Access Compliance Report

Public Rights-of-Way

(Curb Ramps)

Intersection ID: 28304	Main Street: LANCASTER_HY	Cross Street: JOHNSTON_RD	Location: SW
ADA ID: 356E435B4338	Ramp Type: BlendTrans1	Initial Pass/Fail: Pass	Overall Compliance: No
Severity Score: 0.25			
Codes/Mitigation Info/Possible Solution		Field Measurements/Component Compliance

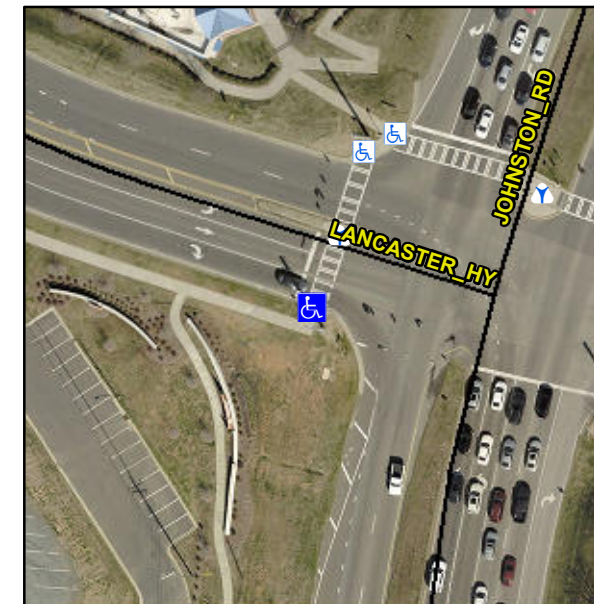
Not Found, R305.1.4

Compliance	Description	Data	Compliance	Description	Data
N/A	Ramp Length (in)	102.0	Yes	BlendTrans Slope (%)	2.3
Yes	Ramp Width (in)	50.5	Yes	BlendTrans XSlope (%)	2.4
N/A	Flare Type LT	Sloped	N/A	Flare Type RT	Sloped
N/A	Flare Slope LT (%)	6.4	N/A	Flare Slope RT (%)	7.4
N/A	Flare Traversable LT?	No	N/A	Flare Traversable RT?	No
Yes	Landing Length (in)	72.0	Yes	DWS Provided?	Yes
Yes	Landing Width (in)	50.5	Yes	DWS Contrast?	Yes
Yes	Landing Slope (%)	1.3	No	DWS Length (in)	23.5
Yes	Landing X Slope (%)	0.0	Yes	DWS Full Width?	Yes
N/A	Landing Curb? (Y/N)	No	Yes	DWS Offset (in)	2.0
N/A	Shared Landing?	No			
Yes	Gutter Ponding?	No	Yes	Gutter Slope (%)	3.4
Yes	Gutter Lip Ht (in)	0.0	Yes	Gutter X Slope (%)	0.1
N/A	Painted X Walk1?	Yes	N/A	Painted X Walk2?	N/A
	X Walk 1 Direction	To NE		X Walk 2 Direction	N/A
	X Walk 1 Width (in)	103.0		X Walk 2 Width (in)	N/A
	X Walk 1 Slope (%)	4.8		X Walk 2 Slope (%)	N/A
	X Walk 1 X Slope (%)	3.4		X Walk 2 X Slope (%)	N/A

Yes	Ramp inside XWalk1?	Yes	N/A	Ramp inside XWalk2?	N/A
	Road Slope (%)	3.4		Clear Space?	Yes
	Road X Slope (%)	4.8	N/A	Clear Space to XWalk (in)	N/A
Yes	Any Obstructions?	No	Yes	Storm Grate/Utility Hazard?	No
	Obstruction Type			Storm Grate/Utility Type	
		N/A			N/A
			Yes	Surface Condition? (G/P)	Good
			No	Curb Slope (%)	7.6

Remove & Replace Curb Ramp With Two New Directional Ramps or Equivalent.
